## Report of the Chief Planning Officer

### SOUTH AND WEST PLANS PANEL

Date: 8<sup>th</sup> February 2018

Subject: POSITION STATEMENT - 17/05126/OT – Outline application for mixed use development for medical centre, retail, six flats and 15 dwellings at Land off Fall Lane And Meadow Side Road, East Ardsley WF3.

SITE PLAN

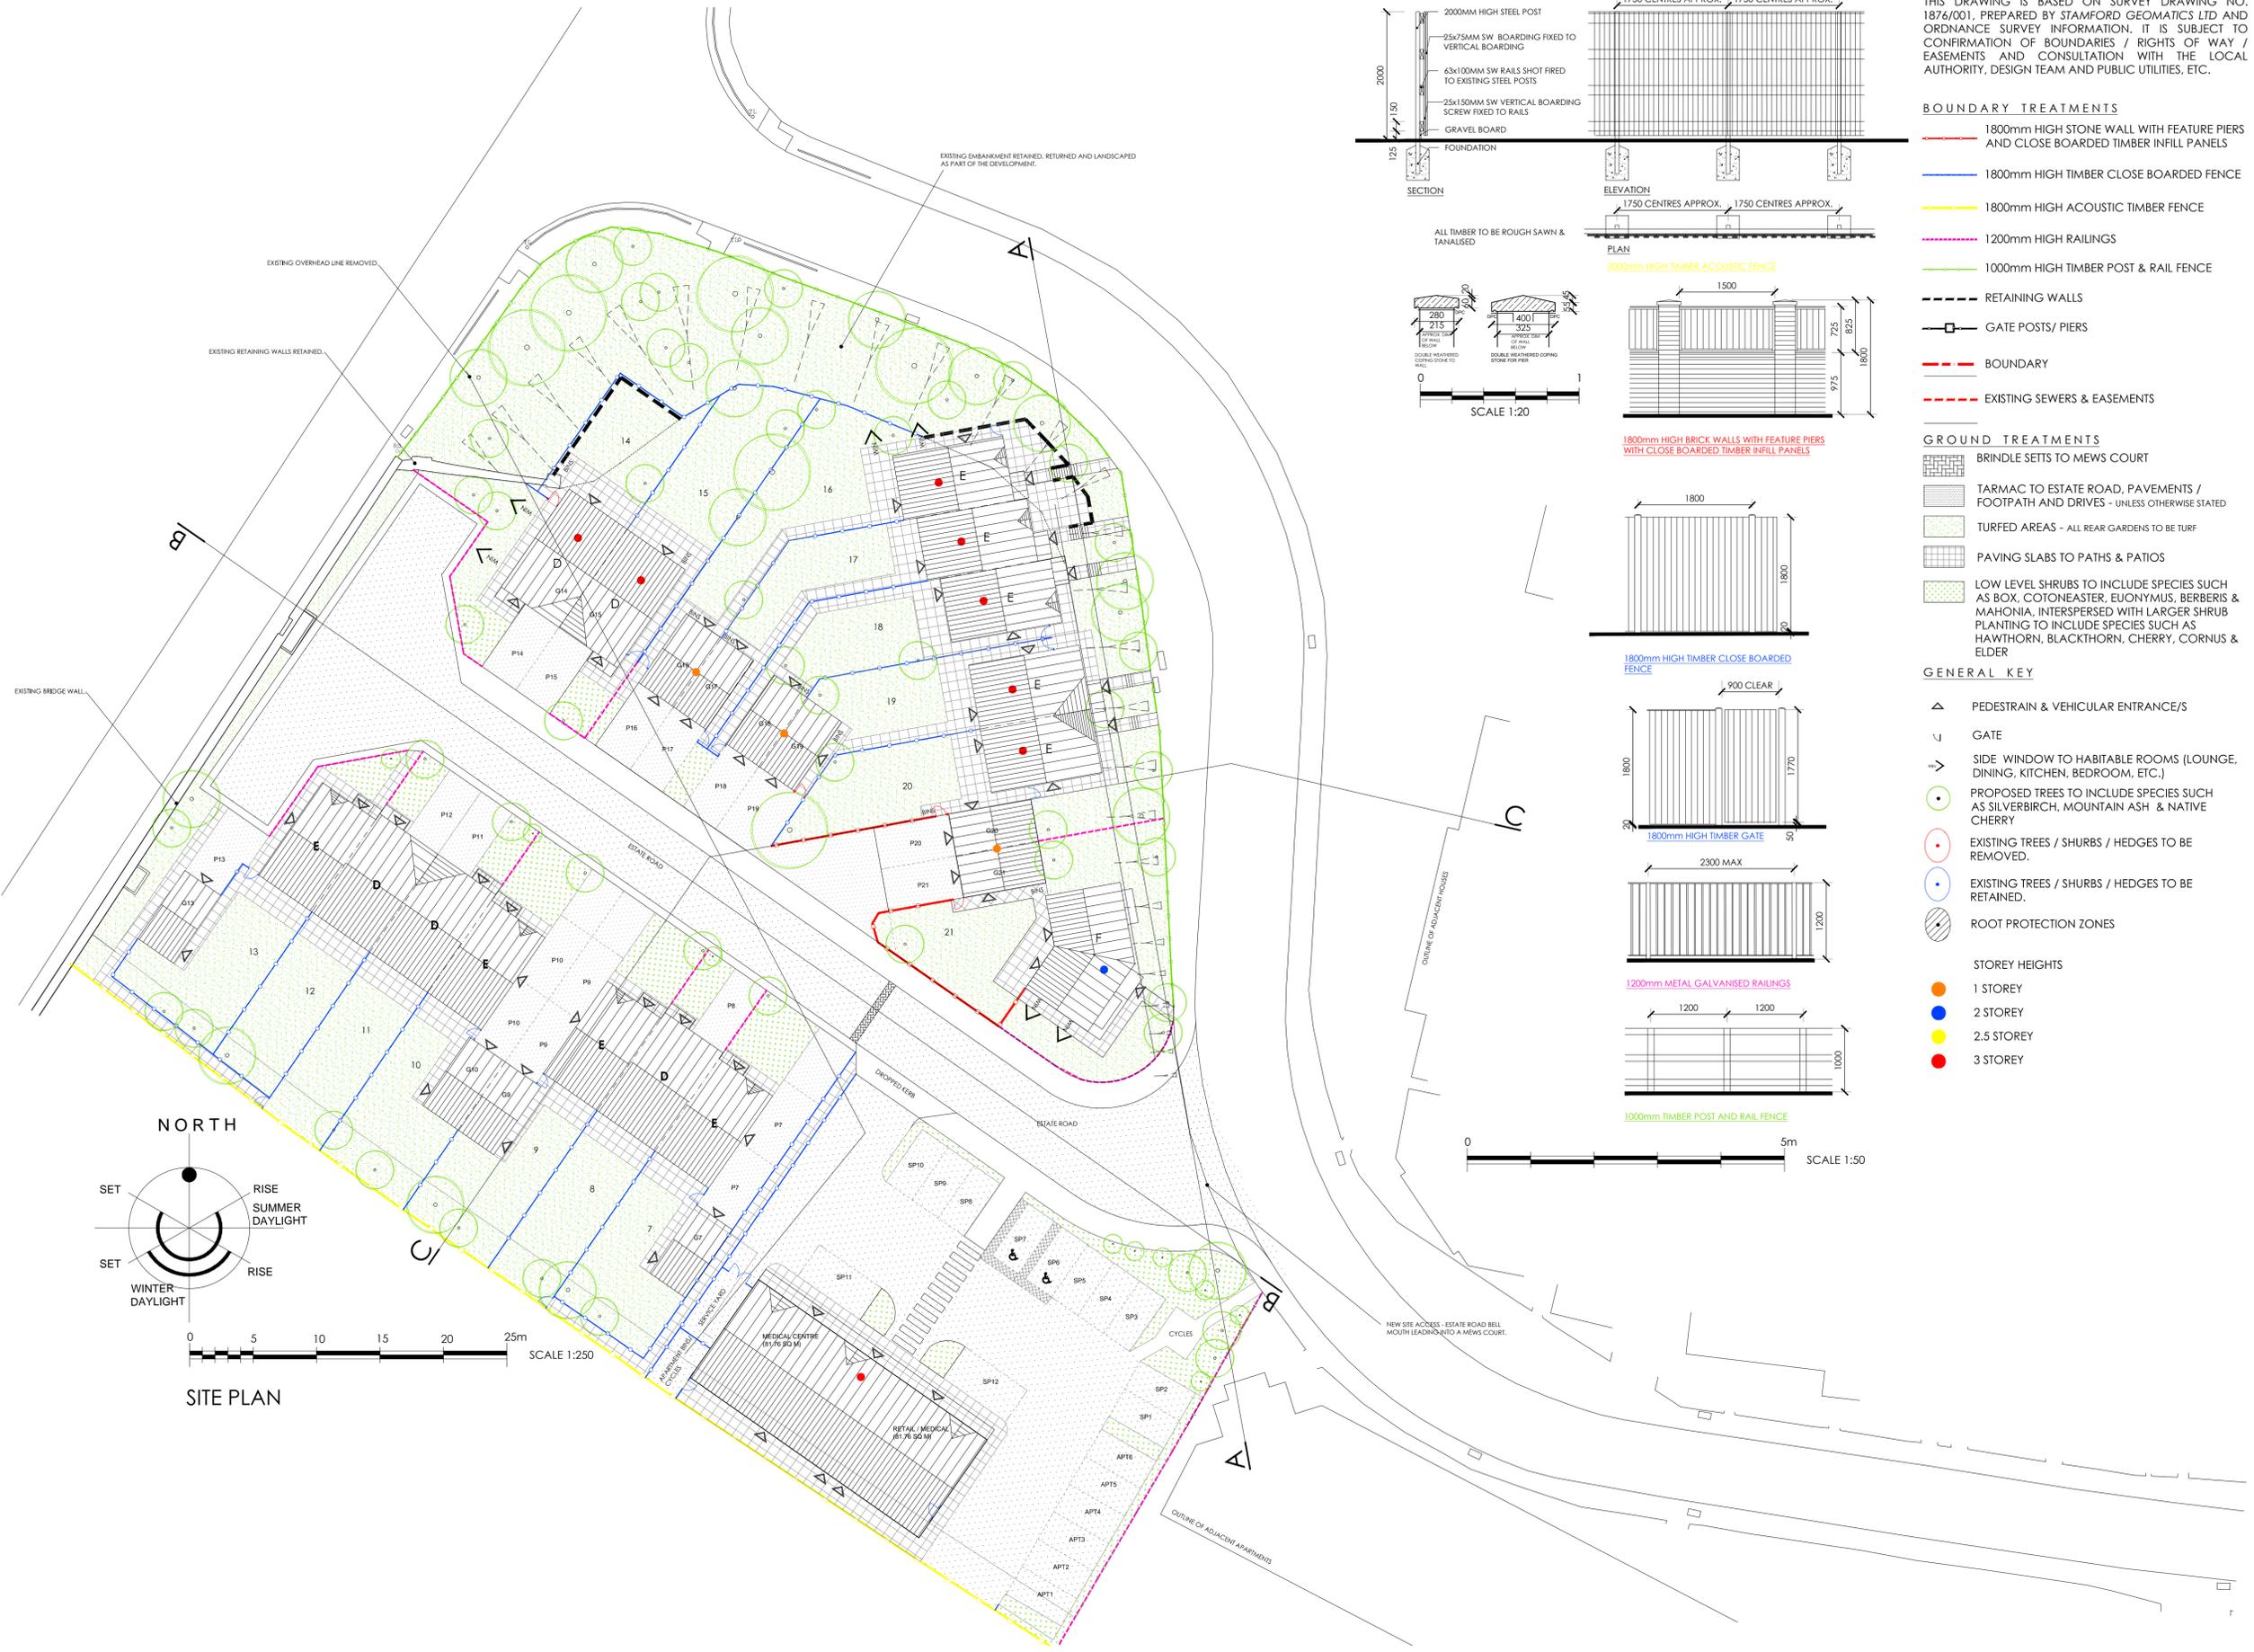
- 10.24 With regards to the detailed design officers have identified some issues. The pair of garages for plots 20 and 21, located in between the semi-detached and detached dwelling (No.21), could appear as incongruous in the streetscene in Meadow Side Road. However it is noted the garages are set well back from the proposed building line of proposed dwellings 20 and 21. The application drawings show tree planting in front of the garages which would provide some visual screening of the garages and provide a visual break between the semi-detached dwellings and the detached two storey dwelling. The landscaping scheme, to be considered at reserved matters stage, will need to demonstrate that effective screening is provided.

- 10.25 The mixed use block will also be visible in views from Meadow Side Road adjacent to the existing three storey building to the South of the development site, although the building is set back towards the southern boundary with car parking to the front and side. It is considered that further landscaping within the car park area would be required, details of which are to be reserved. Limited detail in terms of the design of the shopfront is provided and it is considered that details drawings would be required by condition.

- 10.26 The terraced and semi-detached dwellings will also be visible from Meadow Side Road looking north-west. Some of the dwellings which back on to the railway line (7-13), dwellings in Plots 14 and 15 and the detached garages for plots 16-21 will be largely screened from views looking south by the proposed dwellings fronting Meadow Side Road, although some will be visible above the garage.

- 10.27 The proposed layout, with the garages for flats 16-21 fronting the internal road, is unusual. However there are other examples of single storey garages which form part of the street scene along Meadow Side Road and therefore this arrangement could be considered compatible with the surroundings.

- 10.28 The provision of integral garages for plots 8, 11, 12, 14 and 15 results in no front windows at ground floor level. Neighbourhoods for Living (Update 2015) recognises the importance of providing active frontages with ground floor rooms and windows

facing the street. The guidance recognises that streets which have integral garages and no interplay between the outside and inside is not an appropriate response. Whilst it is recognised that the proposed development does contain several properties with integral garages, there are ground floor front facing windows in the adjacent properties, Nos. 7,9,10 and 13 which provide natural surveillance for this part of the site. The appearance of the integral garages was also raised as an issue by officers at pre-application stage and during the course of the application. However, this aspect of the scheme has not been revised.

10.29 Concerns have also been raised regarding the form of Dwelling 21 in terms of its splayed form which is considered to appear as incongruous within the streetscene and the proposed development. The applicant has sought to justify the proposed design of dwelling 21 stating that it has been designed to address both the access road.

- i) The proposed site layout is generally considered to comply with this guidance. The private rear gardens range in size from approximately 63m<sup>2</sup> to 123m<sup>2</sup>. The proposed garden sizes meet the guidance in that they equate to two thirds of the Gross Internal Area. There are two exceptions, namely Plot 19 (63m<sup>2</sup>) and Plot 14 (70m<sup>2</sup>) which fall below the required 76m<sup>2</sup>.

- vi) Dwellings 13, 15 and 19 do not maintain the required 2.5m to the side boundary. However these properties do not have side facing windows and therefore this does not raise any privacy issues.

- 10.41 The location of the proposed vehicular access is considered acceptable. Some further amendments to the access are required including relocating the dropped kerbs and tactile paving further from the mouth of the junction.
